September 16, 2022

Subject: GCPP22-0005/ SUBFY2022-0005  
8373 Chinden Boulevard  
Chinden Townhomes

The applicant is requesting approval of a planned unit development, design review, and a preliminary plat application to allow for the development of a 77-lot residential subdivision consisting of 76-residential lots and 1 common lot to allow the construction of 76 single-family attached townhome units on 7 acres.

# SITE PLAN

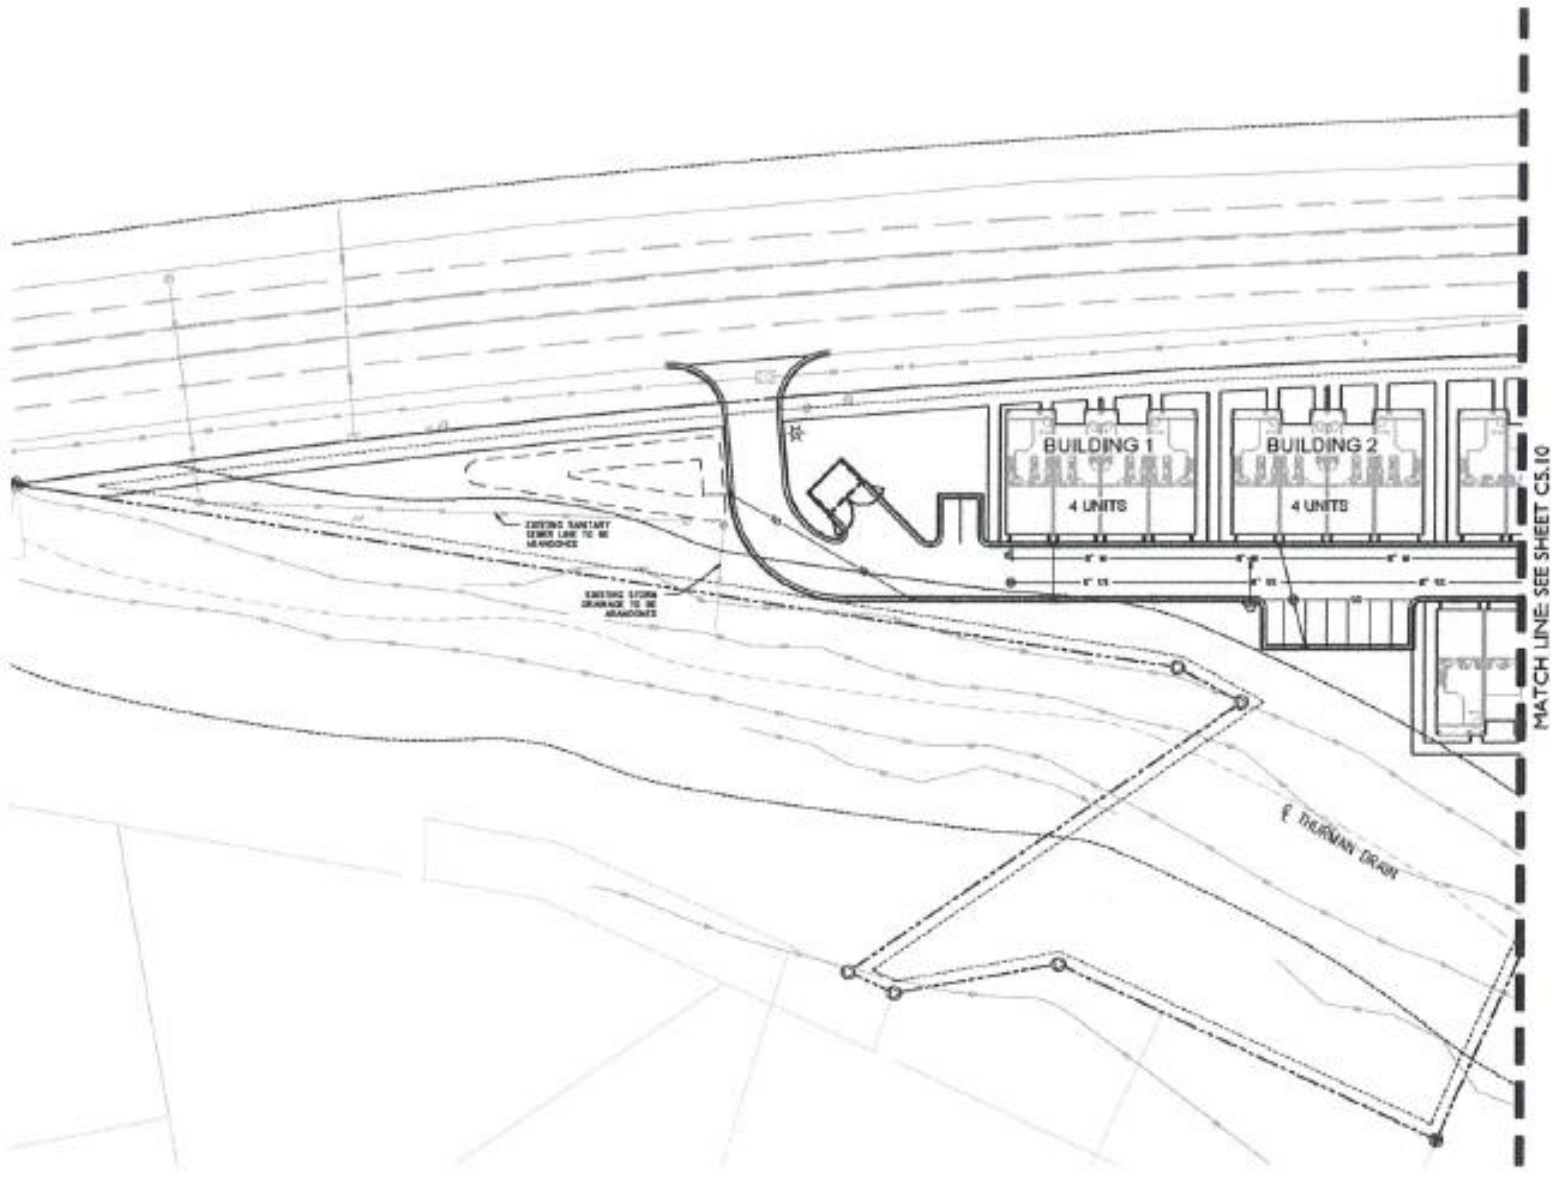
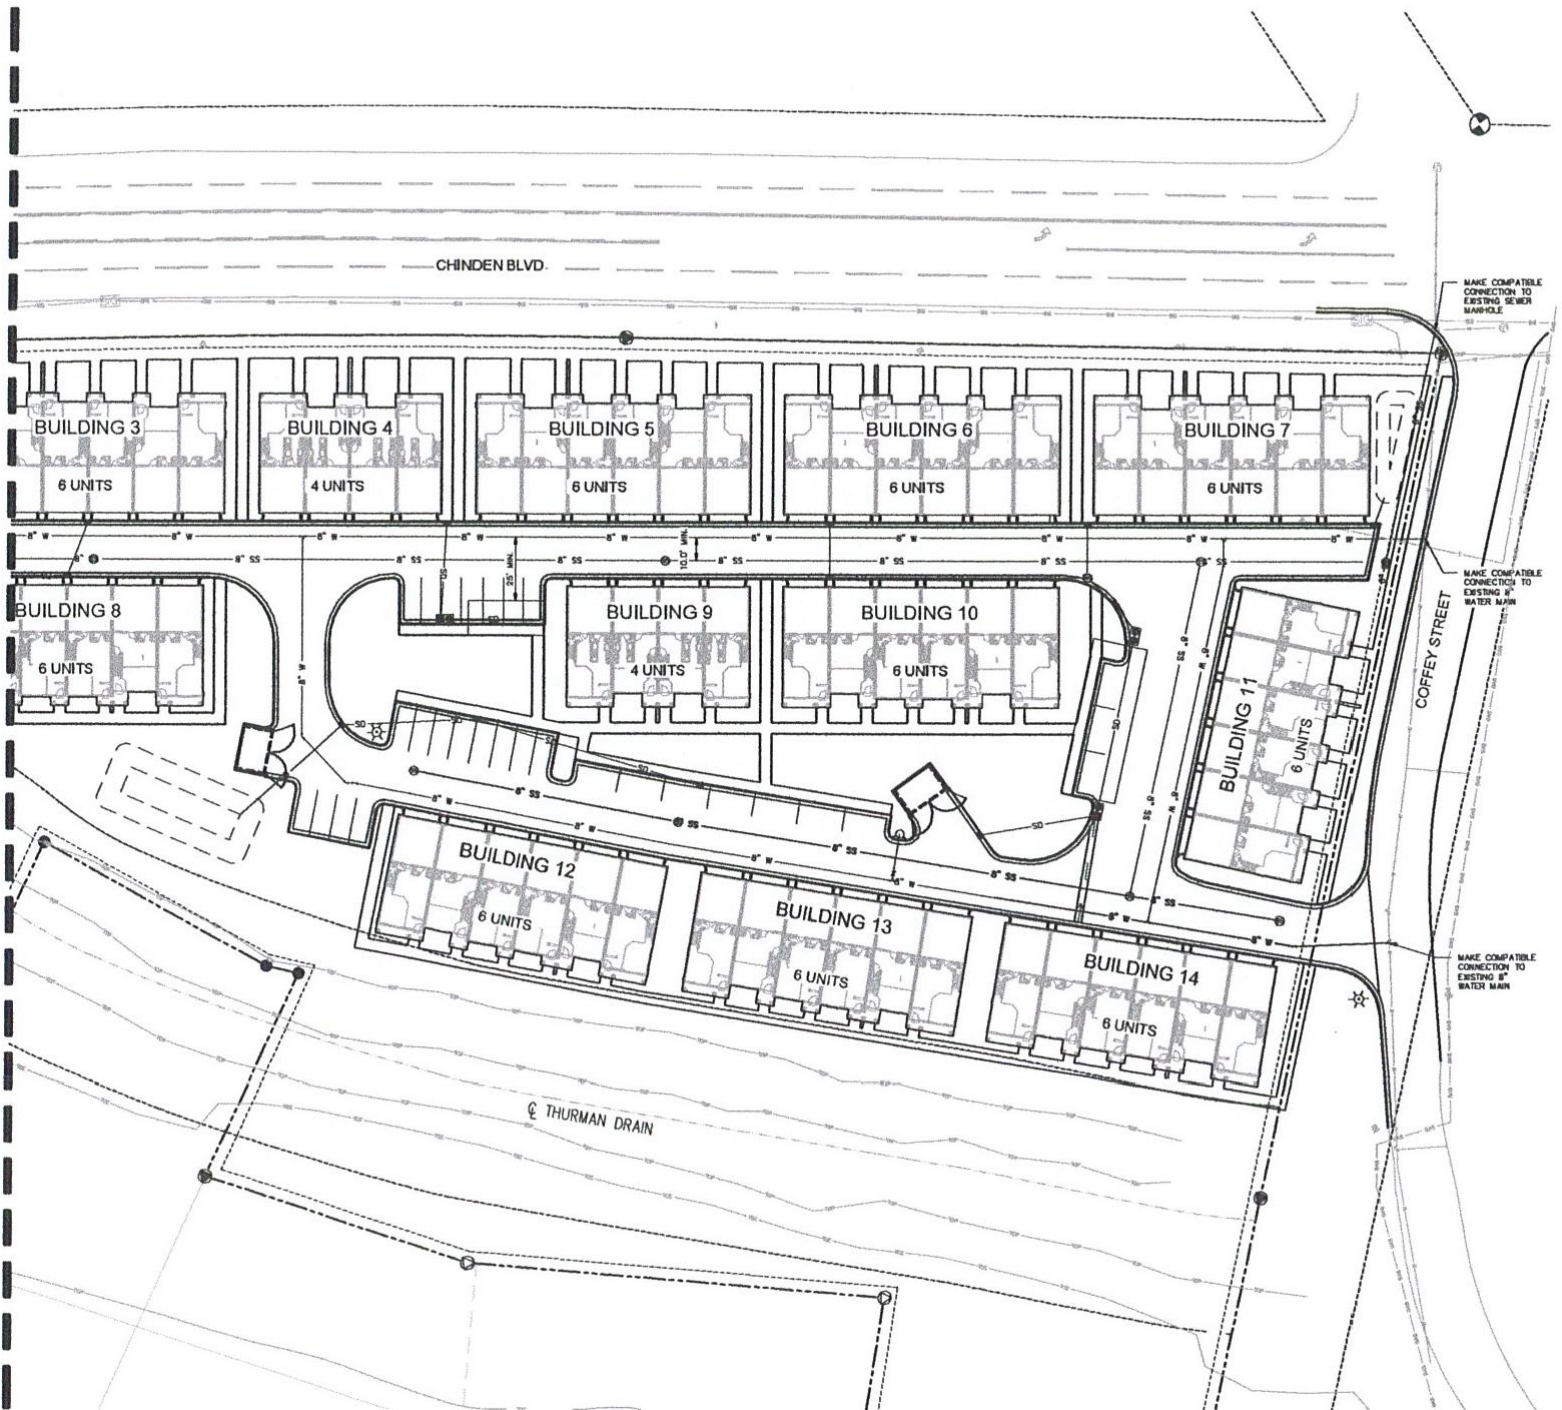
- c. **Applicant's Proposal:** The applicant is proposing to improve Coffey as half of a 32-foot street section to include curb, gutter, and 6-foot wide planter strip and 5-foot wide detached concrete sidewalk abutting the site.
- d. **Staff Comments/Recommendations:** The applicant's proposal does not meet District policy and should not be approved as proposed.

The applicant should be required to improve Coffey Street as half of a 36-foot wide local commercial street section to include pavement widening, curb, gutter, and 5-foot wide attached or detached concrete sidewalk abutting the site. If attached sidewalks are constructed, then dedicate additional right-of-way to extend 2-feet behind the back of the sidewalk or 2-feet behind the back of curb for detached sidewalks. If Street trees are desired, then an 8-foot wide planter strip should be provided. A permanent right-of-way easement should be provided for detached sidewalks located outside of the dedicated right-of-way.

The applicant should be required to design and construct the improvements to maintain the existing centerline alignment of Coffey Street with Coffey Street on the north side of Chinden Boulevard/ US-20-26 across from the site.

- c. **Applicant's Proposal:** The applicant is proposing to reconstruct the existing 30-foot wide driveway as a 26-foot wide paved curb return type shared driveway from the site onto Coffey Street, located 305-feet south of US-20/26.
- d. **Staff Comments/Recommendations:** The applicant's proposal meets District policy and should be approved as proposed.

1. Widen Coffey Street to half of a 36-foot wide local commercial street section with pavement widening, vertical curb, gutter, and either a 5-foot wide attached or detached concrete sidewalk abutting the site.
2. If an attached sidewalk is constructed dedicate additional right-of-way to extend right-of-way to 2-feet behind back of sidewalk and or 2-feet behind the back of curb for a detached sidewalk. If street trees are desired, then an 8-foot wide planter strip is required.
3. Maintain the existing centerline alignment of Coffey Street with Coffey Street on the north side of Chinden Boulevard across from the site.
4. Reconstruct the existing driveway on Coffey Street, located 350-feet south of Chinden Boulevard/SU-20/ as a 26-foot wide paved, curb return type shared driveway, as proposed.
